**Date:** March 9, 2022

**Subject:** Falcon Commerce Center Filing No. 2 - Civil Construction Plans

FALCON COMMERCE CENTER FILING NO. 2  
CIVIL CONSTRUCTION PLANS  
TERRAZZO DRIVE EXTENSION AND UTILITY IMPROVEMENTS  
MONUMENT, COLORADO

SHEET  
**C502**  
OF 26 SHEETS

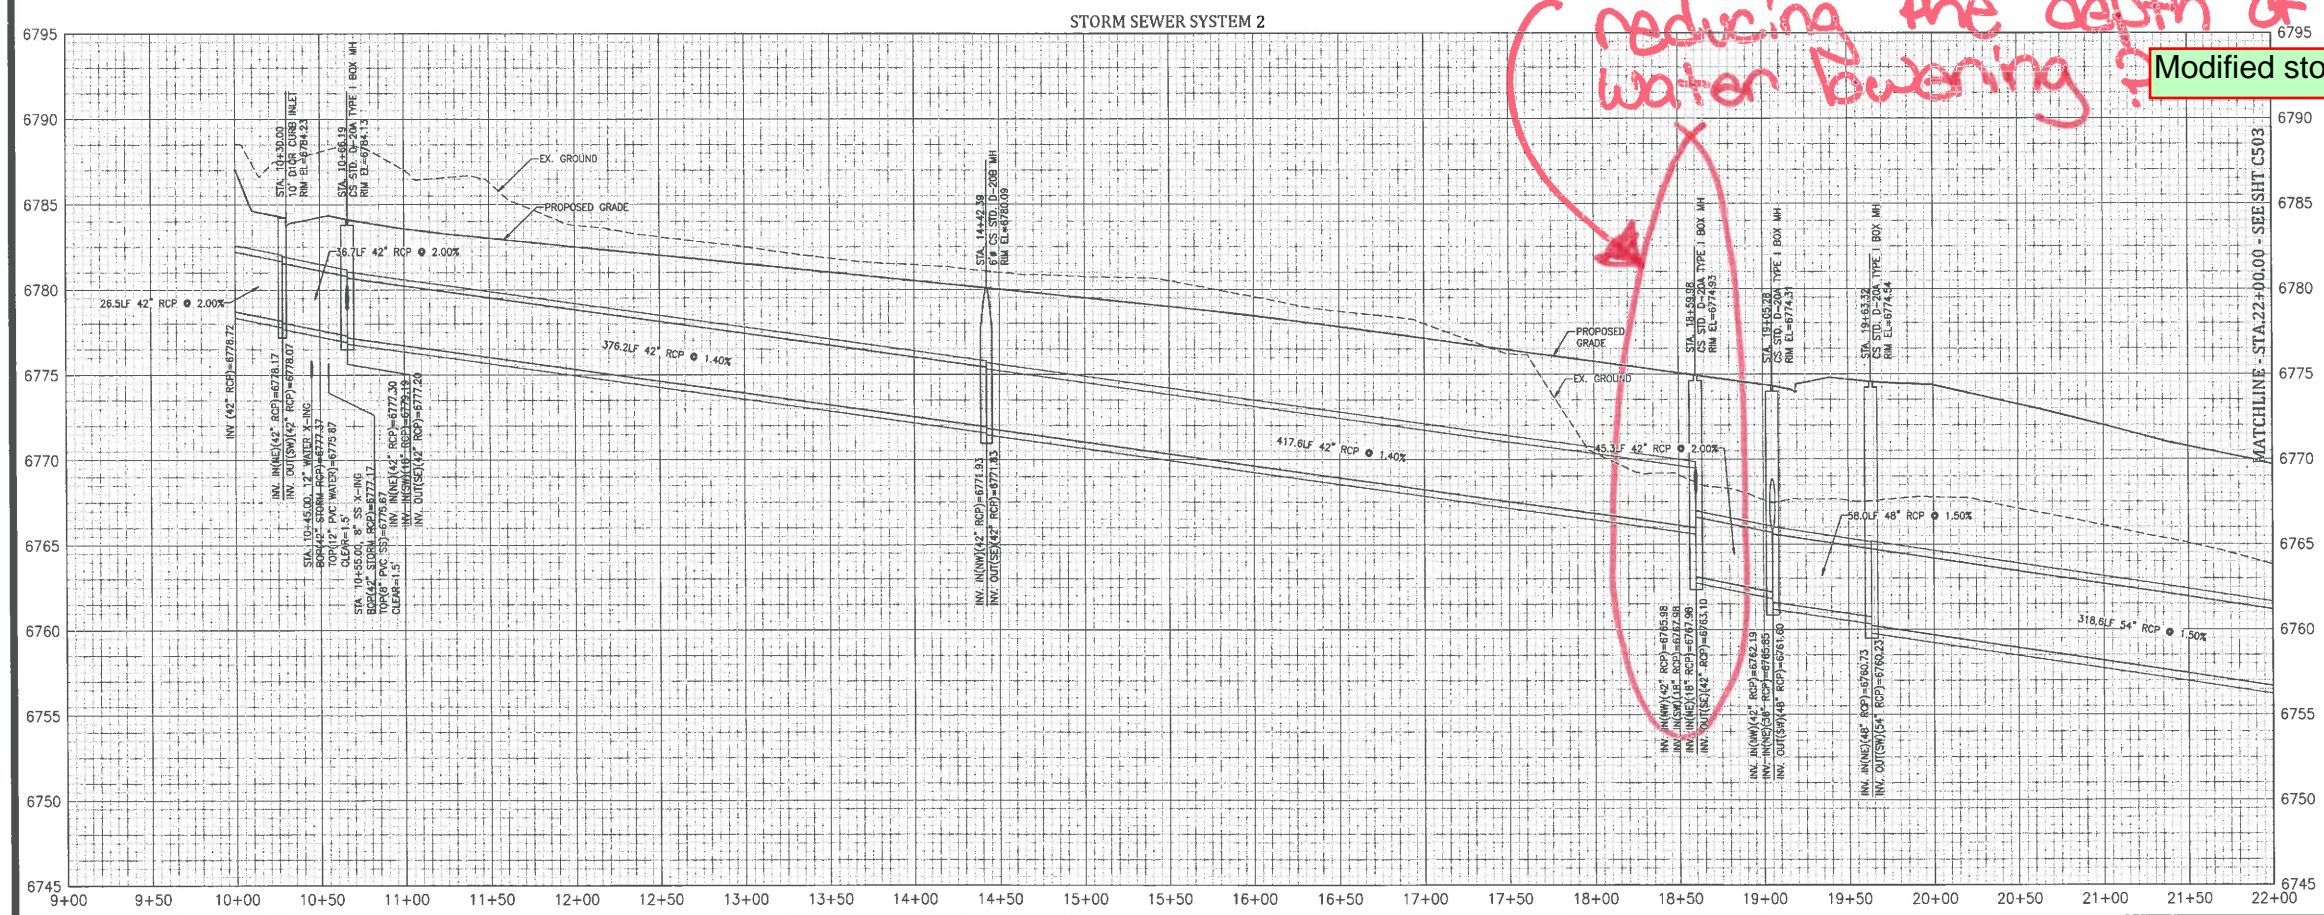
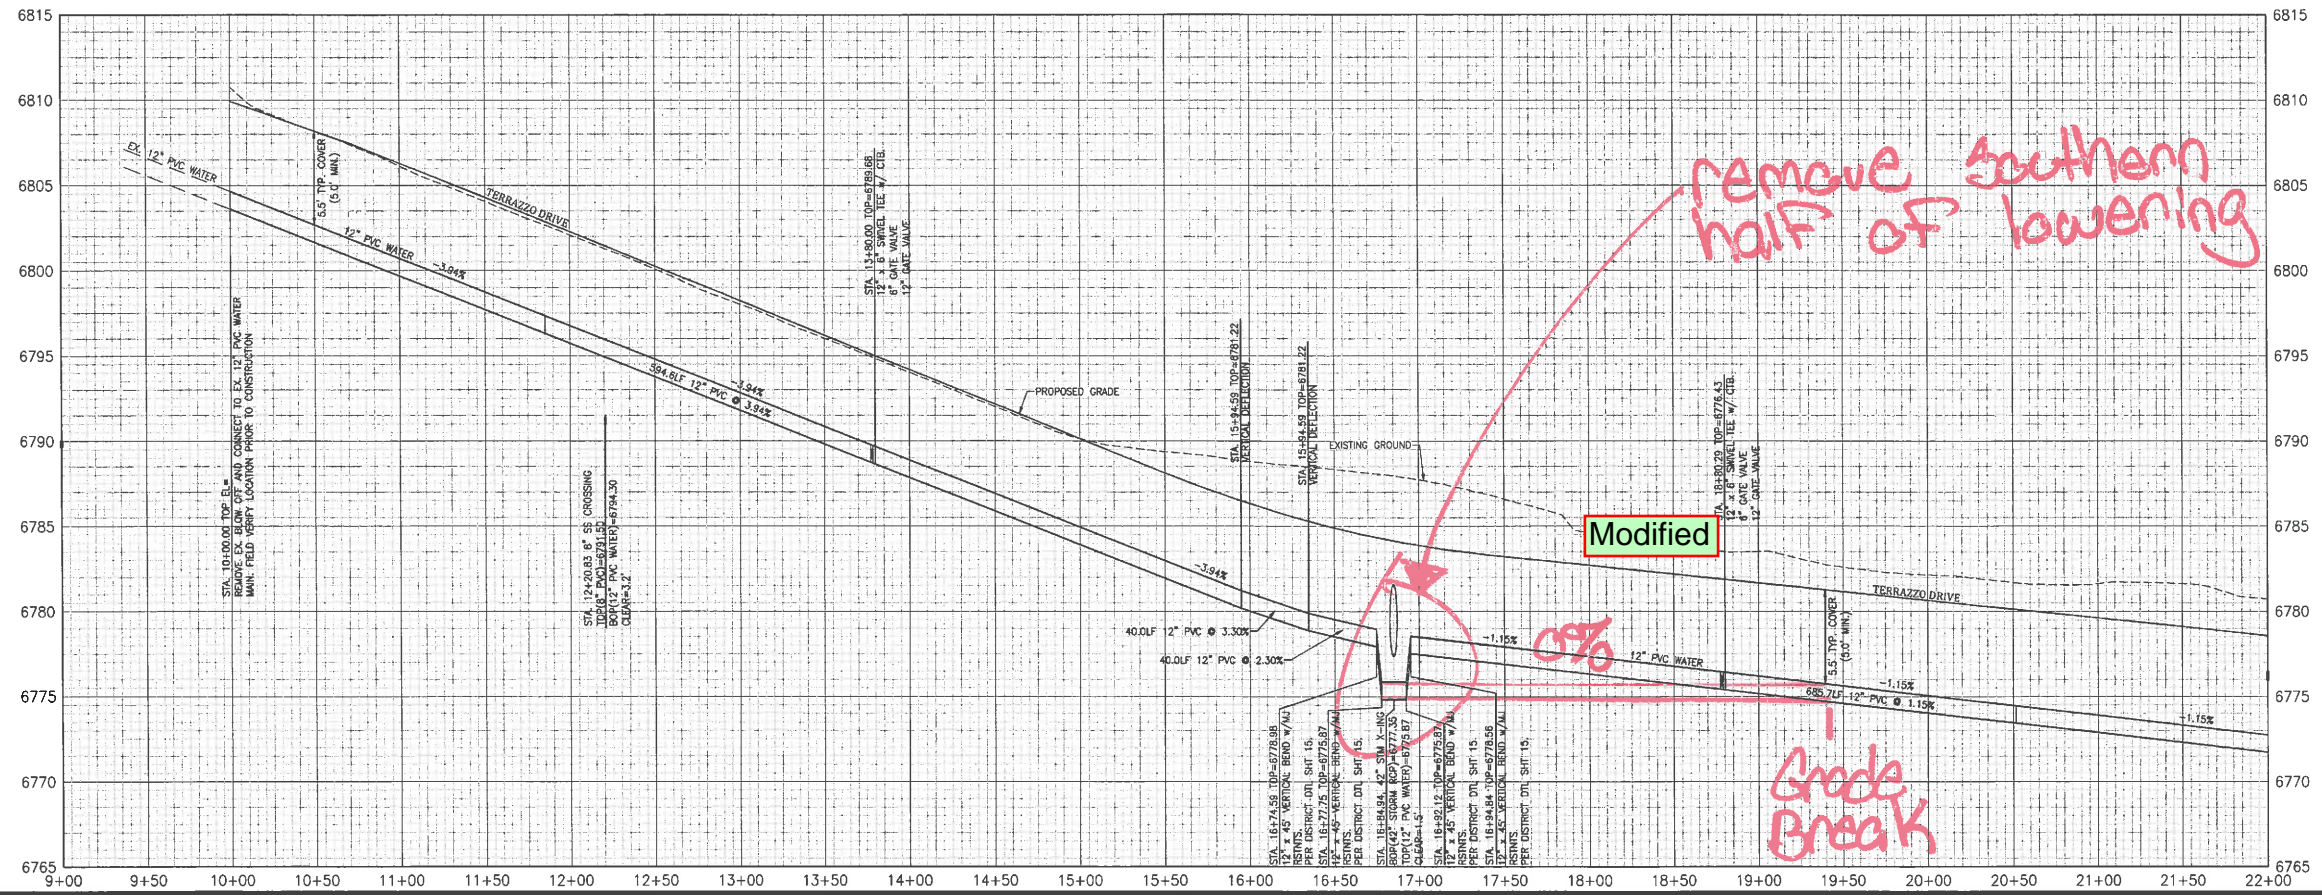
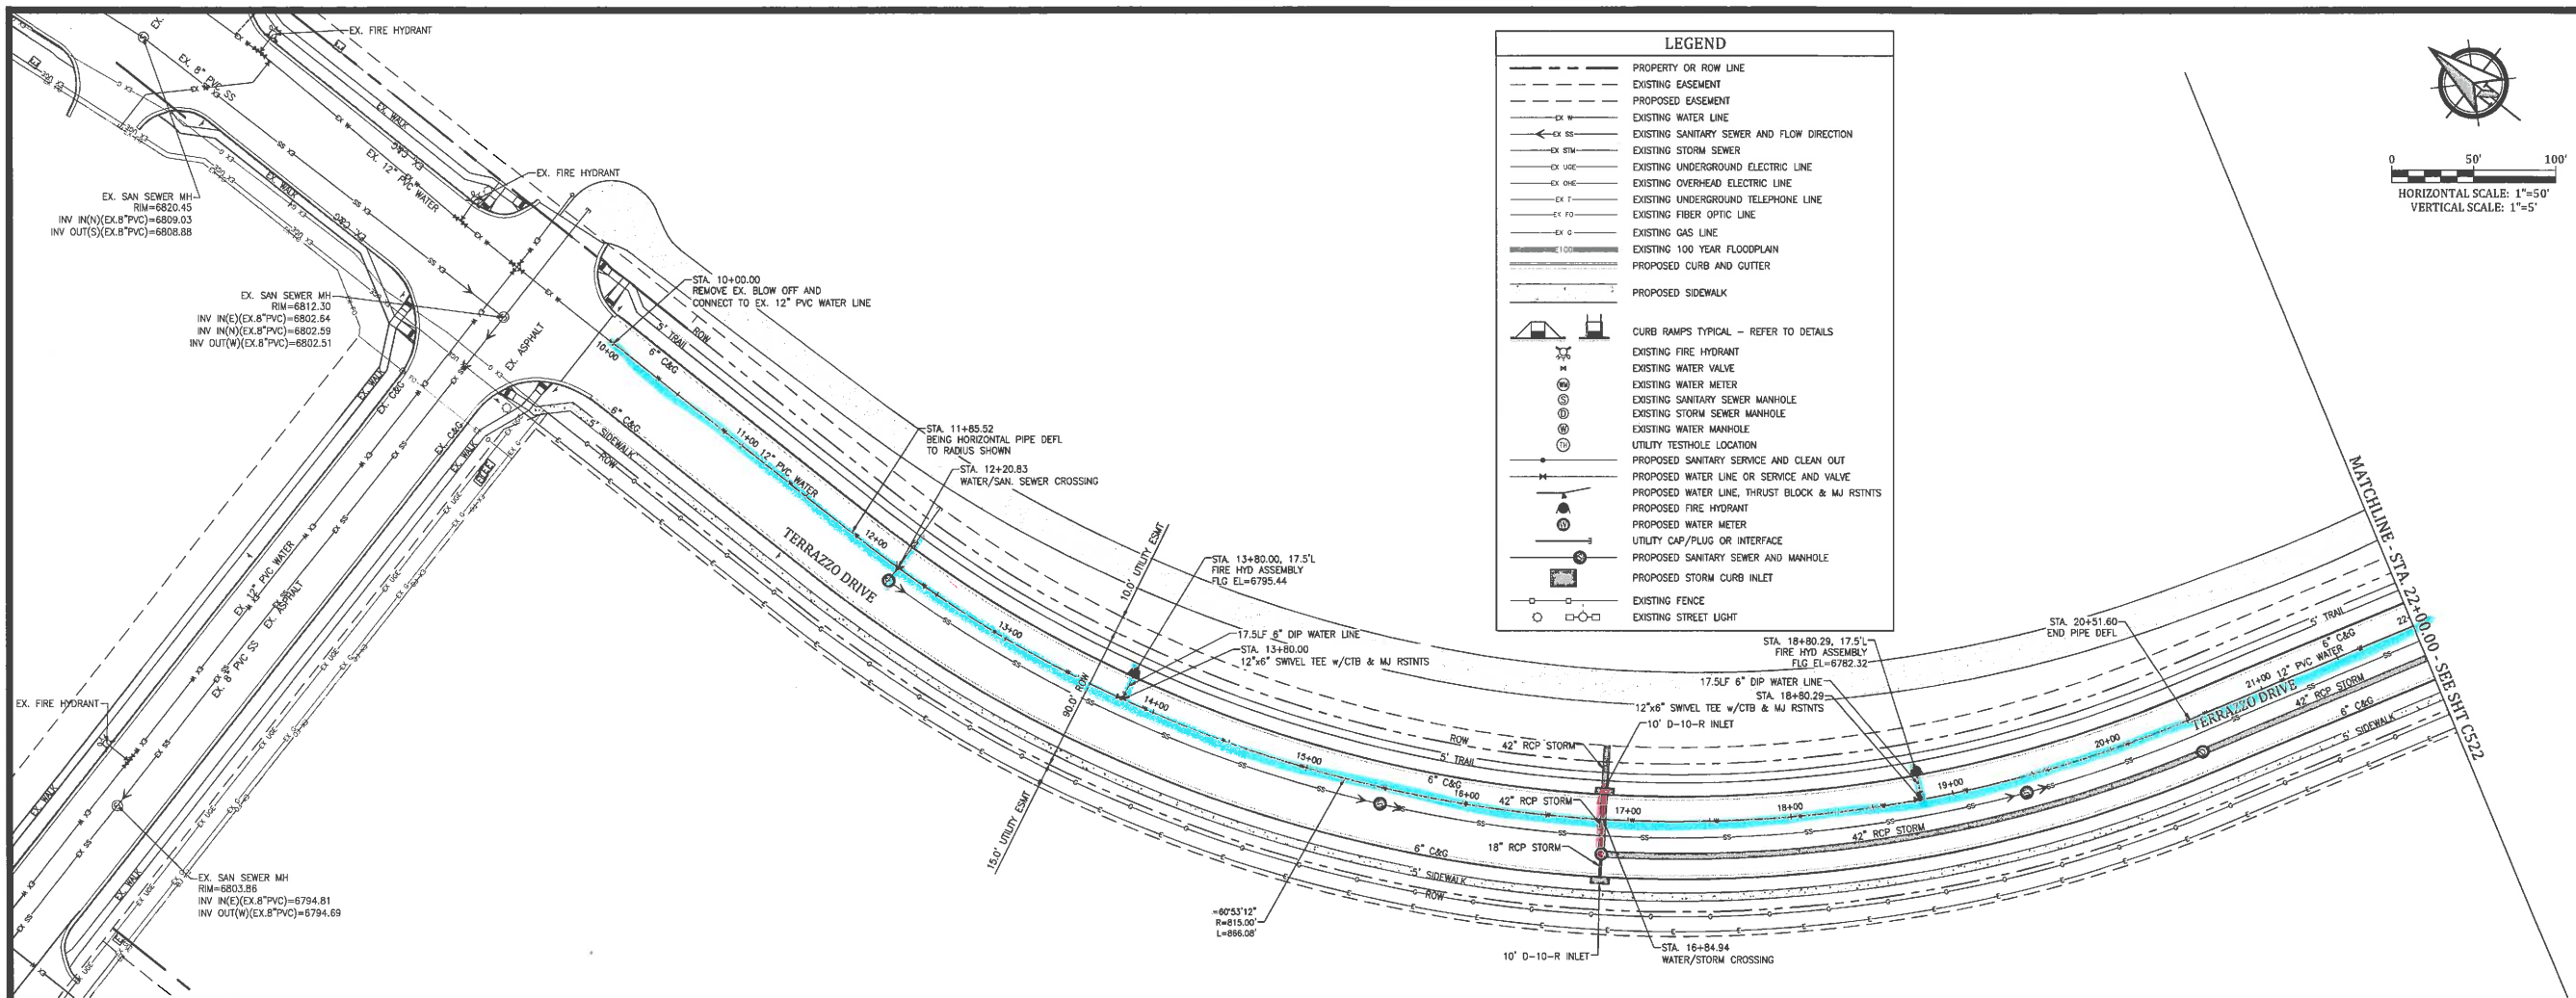
- / On Sheet C502, it appears that there is a significant drop through the manhole at Station 18+59. Could the drop through this manhole be reduced? This reduction could allow the depth of the water line lowering under the proposed storm sewer to be reduced as well.

It appears that there is significant fall through MH @ Sta 18+59. Could the fall be reduced to reduce the depth of the storm sewer thus reducing the depth of the required water lowering?

Modified storm depth
